Subject: Corridors in Historic Highrise Apartment Buildings and Hotels

- Applicable Standards:**
- 2. Retention of Historic Character
 - 5. Preservation of Distinctive Features, Finishes and Craftsmanship

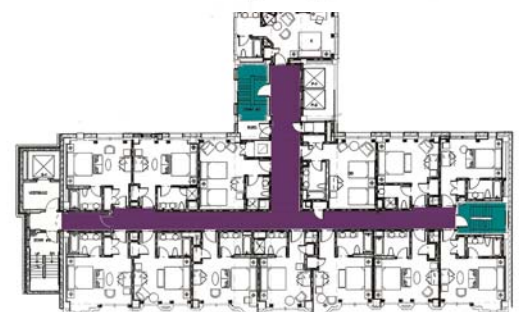
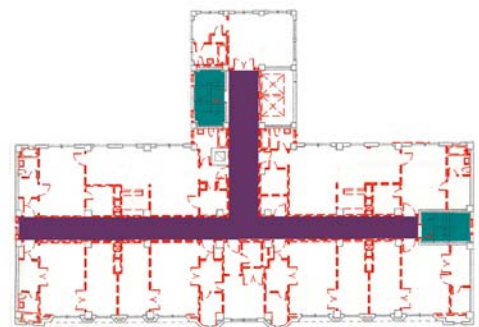
Application 1 (*Incompatible treatment*): Completed in 1926, this ten-story brick and terra cotta building was originally an apartment hotel (“bachelor” apartments without kitchenettes on the first floor and efficiency apartments on the remaining floors). Eventually, it was converted to hotel use only. The building is distinguished by virtually intact historic fabric and floor plans, including a T-shaped, double-loaded corridor system on floors two through ten. The rehabilitation proposal calls for gutting of these floors, which are in excellent condition, and construction of new corridors and hotel rooms. While the new corridor system would essentially reproduce the shape of the historic corridor system, the proposal to completely eliminate intact, character-defining features, finishes and spaces, including the apartment layouts, does not meet the Standards.

TOP RIGHT: Proposed demolition plan for each of the upper floors. Red, dotted lines indicate removal of original corridor and room partitions with the historic trim and detailing.

BOTTOM RIGHT: Proposed plan for the upper floors. The longer section of the new corridor is narrower than its historic counterpart. All finishes, detailing and trim would be imitations of the original.

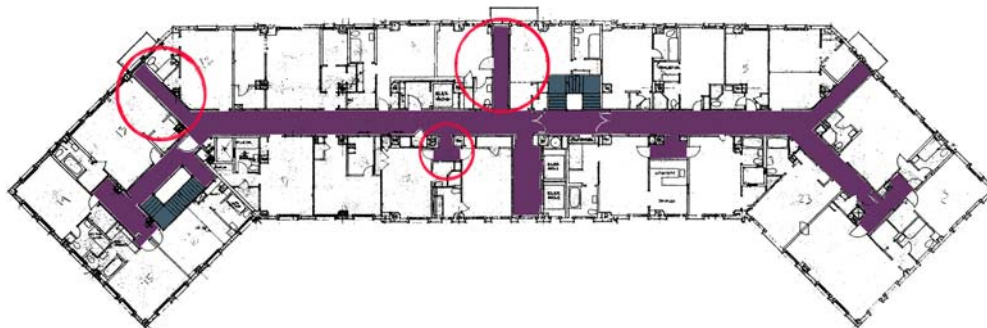
Application 2 (Compatible treatment): Opened in 1927 to serve as an apartment hotel (originally, 85 apartment suites and 32 hotel rooms), this building is a fifteen-story, reinforced-concrete tower. Over the years, virtually all of the building became a hotel. Then, as part of the recent rehabilitation, the building shifted back to apartment building use. Above lobby level, the floors are served by double-loaded corridors that follow the footprint of the wide central section of the building and its diagonal end wings. The rehabilitation retained the elevator lobbies, corridors, and the associated historic fabric, with a few minor modifications (the basic room configuration was also retained, with some grouping of rooms to create apartments). Two small corridor “access ways” for fire escapes were converted to private space for adjacent apartments (as the fire escapes themselves were eliminated); drywall was laminated to the deteriorated plaster walls (historic trim and detailing were retained); and a drywall ceiling was dropped slightly below the historic flat plaster ceiling to accommodate the new mechanical, electrical and plumbing systems. This work preserves the historic character of the corridors and, thus, meets the Standards.

Pre-rehabilitation plan of typical upper floor. Circled areas indicate the only major changes to the corridor plan to take place during rehabilitation.

Post-rehabilitation plan of typical upper floor. Corridors and staircases have survived intact. Former fire escape “accessways” have been absorbed into two apartments and a vestibule is absorbed into one apartment on each floor. Shown in lavender are intact, previously public areas (a small vestibule and the end leg of the corridor) that have been incorporated into two of the apartments on each floor.
